**SUBMISSION—HIGGINS SWAMP STRUCTURE PLAN**

## **DRAFT HIGGINS SWAMP STRUCTURE PLAN**

## **SUBMISSION ON HIGGINS SWAMP STRUCTURE PLAN**

**RE: PROPOSED HIGGINS SWAMP STRUCTURE PLAN.**  
**WARREN ROAD, NANNUP. RESPONSE TO**  
**SUBMISSIONS.**

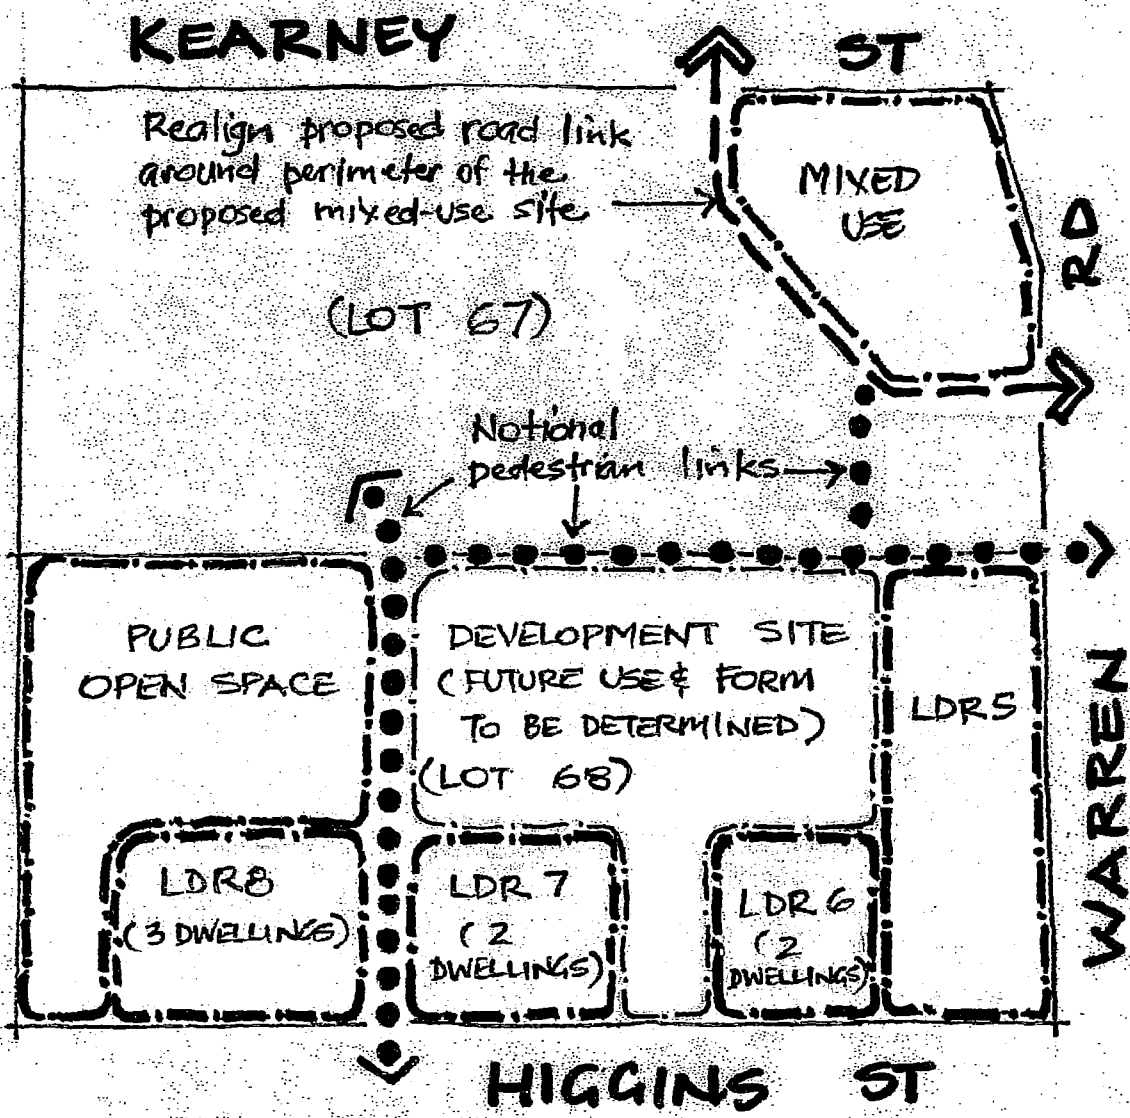
With reference to section 5.6 of the structure plan it is queried as to why further **detailed structure planning** maybe required prior to any further subdivision or development of land within the structure plan area taking place once the structure plan has been adopted by the Shire.

Such a process is a duplication of effort and considerably extends the timeframe for the structure planning process. However, there is no provision within any State Planning Policy or in the Shire of Nannup TPS 3 requiring this.

Section 5.6 of the Structure Plan report identifies that more detailed planning will be required, "including more detailed Structure Plans...prior to subdivision". Clearly, the intent is that further structure planning is only required for applications involving subdivision.

The provisions included in Section 5.6 (and duplicated on the Structure Plan itself) clearly require further detailed structure plans as a precursor to subdivision only. Previous versions of the Structure Plan adopted the terminology "Subdivision Guide Plan" in provision 1d. At the Shire's request this was changed to "Structure Plan". There is no objection to this Provision being reworded to reintroduce "Subdivision Guide Plan"; viz,

1d) *Subdivision will not be supported unless a Subdivision Guide Plan has been adopted by the Shire of Nannup & Western Australian Planning Commission. Where applicable, the Subdivision Guide Plan is to address, inter alia, servicing arrangements, stormwater management, infrastructure (including foot and dual use paths) provision, fill levels and earthworks, environmental considerations, management arrangements for Higgins Swamp, access arrangements, road and pavement widths, lot sizes and configuration and any other reasonable requirements of the Shire and/or WAPC.*
